6 Chaomans Letchworth
Job No. 188 Elevations North BB
as proposed

Stage: Stage 3
Status: **Non-material amendment**

007

North Elevation AA as Proposed

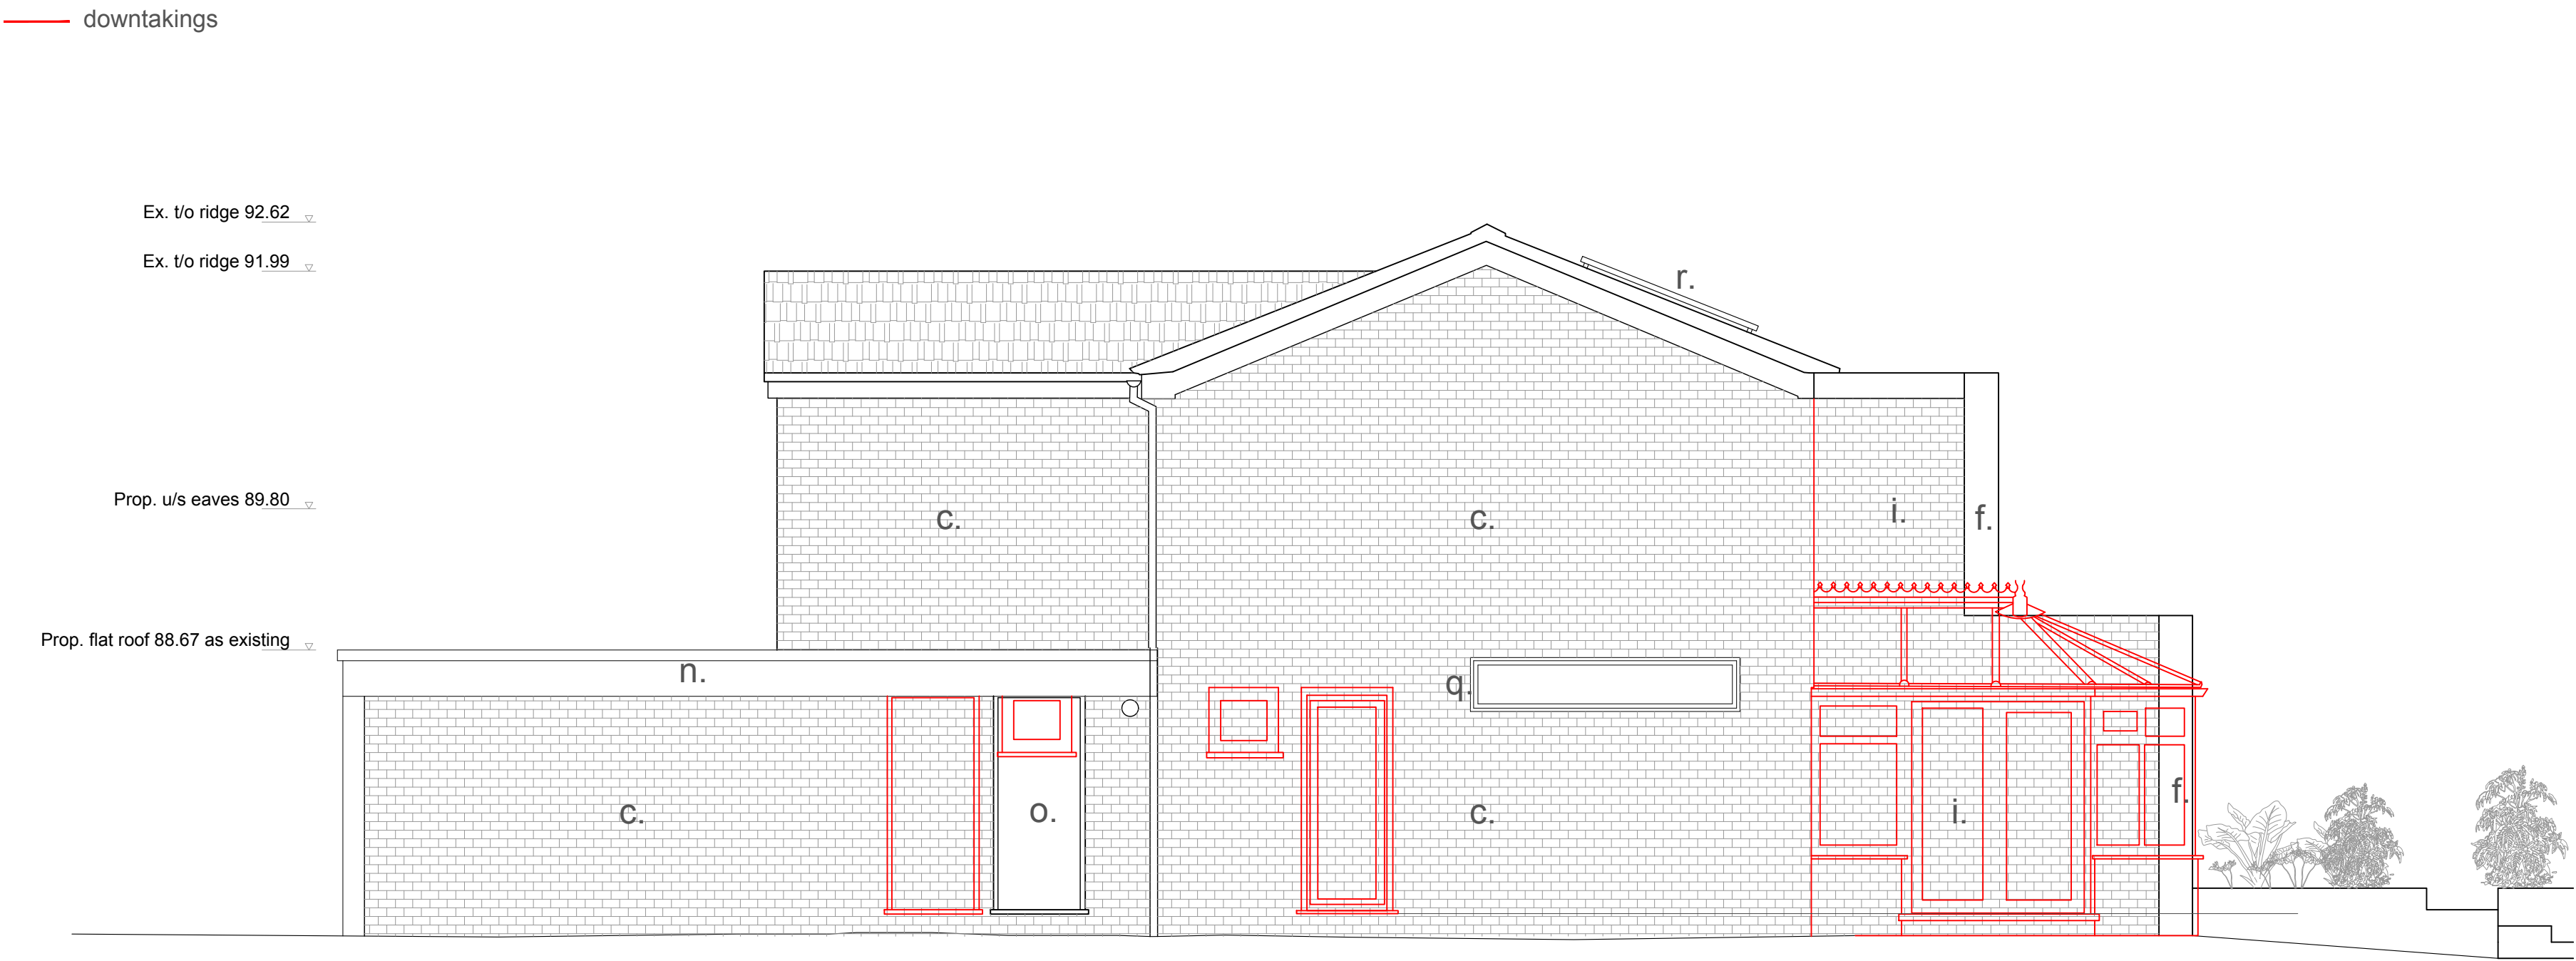
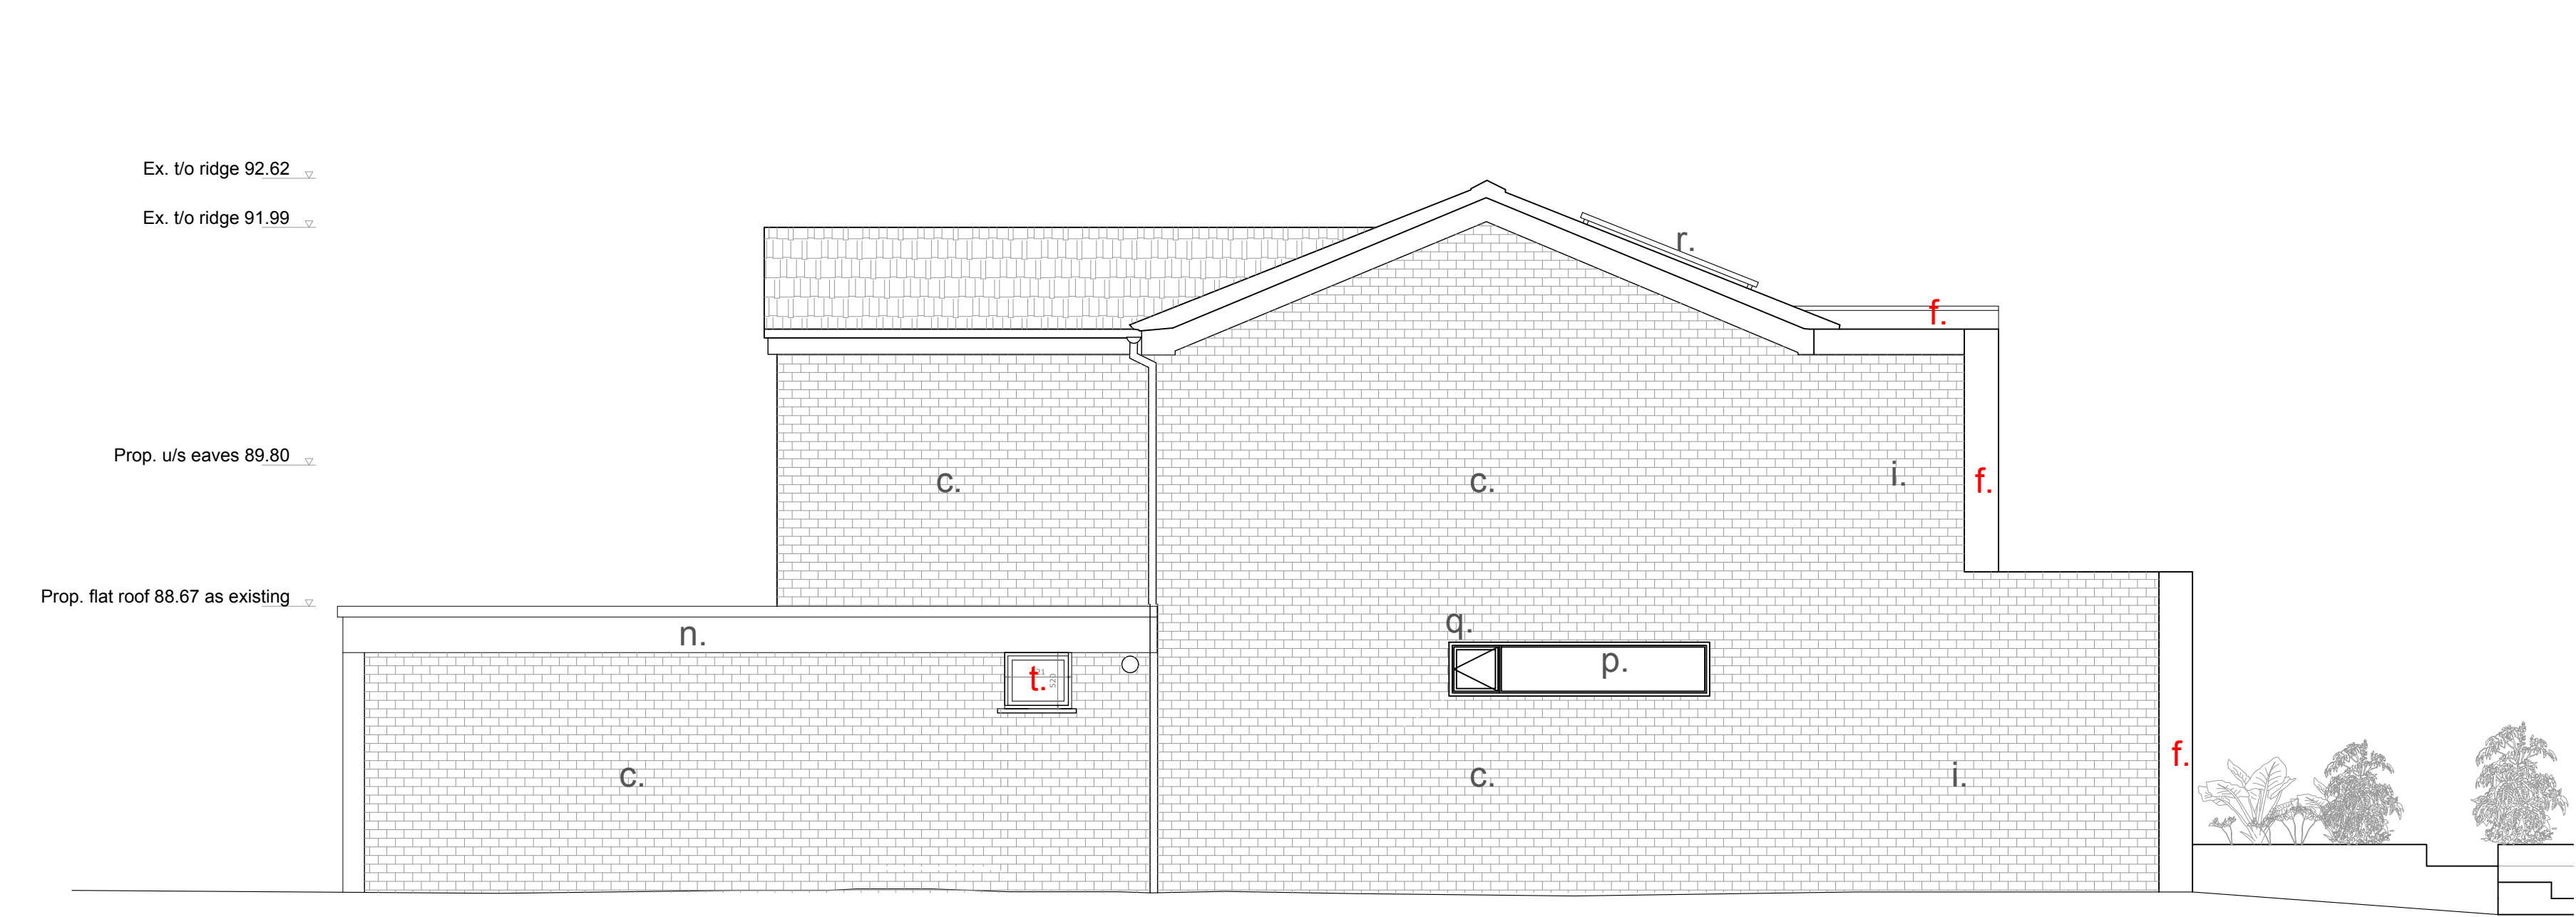
- a. Replace white UPVC existing windows with **aluminium** window - white
- b. New timber front porch door with fixed glazing panel
- c. Existing brick wall
- e. New rooflight
- f. New aluminium RAL 7013 cladding frame**
- g. New **iroko** timber cladding and louvered screen
- h. Existing side gate
- i. New brick wall to match existing
- j. New slimline aluminium sliding doors bronze anodised
- k. New flat roof
- l. Widflower flat roof
- m. Aluminium flashing **RAL 7013**
- n. White fascia
- o. New door - wood
- p. New slimline aluminium windows **RAL 7013**
- q. Oak frame for window
- r. New PV panels
- s. New **white aluminium** window white to match the adjacent windows
- t. Replace existing UPVC windows with aluminium window RAL 7013**
- u. Seamless glazed balustrade**
